# Access Compliance Report

## Public Rights-of-Way

Intersection ID: 20986	Main Street: W_ARROWWOOD_RD	Cross Street: ARROWPOINT_BV	Location:	N
ADA ID: BFB0E331E6D5	Ramp Type: MedianPerp	Initial Pass/Fail: Fail	Overall Compliance: No	Severity Score: 12.5

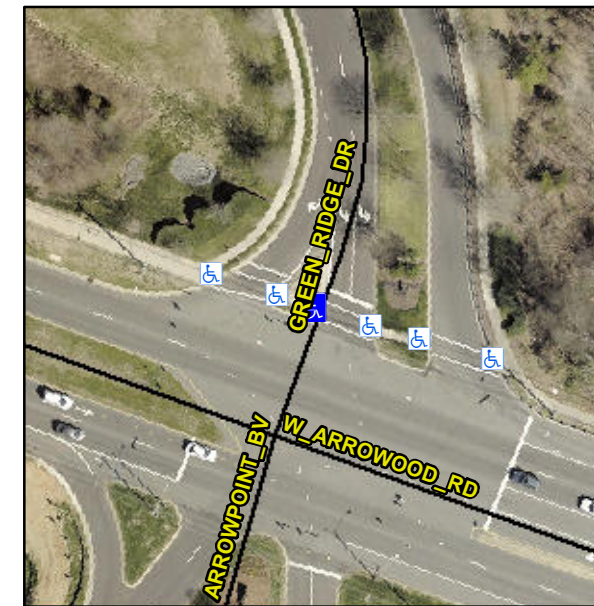
**R304.5.3**

Compliance	Description	Data	Compliance	Description	Data
N/A	Ramp Length (in)	57.5	Yes	Ramp Slope (%)	7.8
Yes	Ramp Width (in)	48.0	No	Ramp XSlope (%)	5.4
N/A	Flare Type LT	N/A	N/A	Flare Type RT	N/A
N/A	Flare Slope LT (%)	N/A	N/A	Flare Slope RT (%)	N/A
N/A	Flare Traversable LT?	N/A	N/A	Flare Traversable RT?	N/A
N/A	Landing Length (in)	N/A	N/A	DWS Provided?	N/A
N/A	Landing Width (in)	N/A	N/A	DWS Contrast?	N/A
N/A	Landing Slope (%)	N/A	N/A	DWS Length (in)	N/A
N/A	Landing X Slope (%)	N/A	N/A	DWS Full Width?	N/A
N/A	Landing Curb? (Y/N)	N/A	N/A	DWS Offset (in)	N/A
N/A	Shared Landing?	N/A			
N/A	Gutter Ponding?	N/A	N/A	Gutter Slope (%)	N/A
N/A	Gutter Lip Ht (in)	N/A	N/A	Gutter X Slope (%)	N/A
N/A	Painted X Walk1?	Yes	N/A	Painted X Walk2?	N/A
	X Walk 1 Direction	To SE		X Walk 2 Direction	N/A
N/A	X Walk 1 Width (in)	106.0	N/A	X Walk 2 Width (in)	N/A
	X Walk 1 Slope (%)	3.7		X Walk 2 Slope (%)	N/A
	X Walk 1 X Slope (%)	1.9		X Walk 2 X Slope (%)	N/A

**Remove & Replace Entire Ramp.**
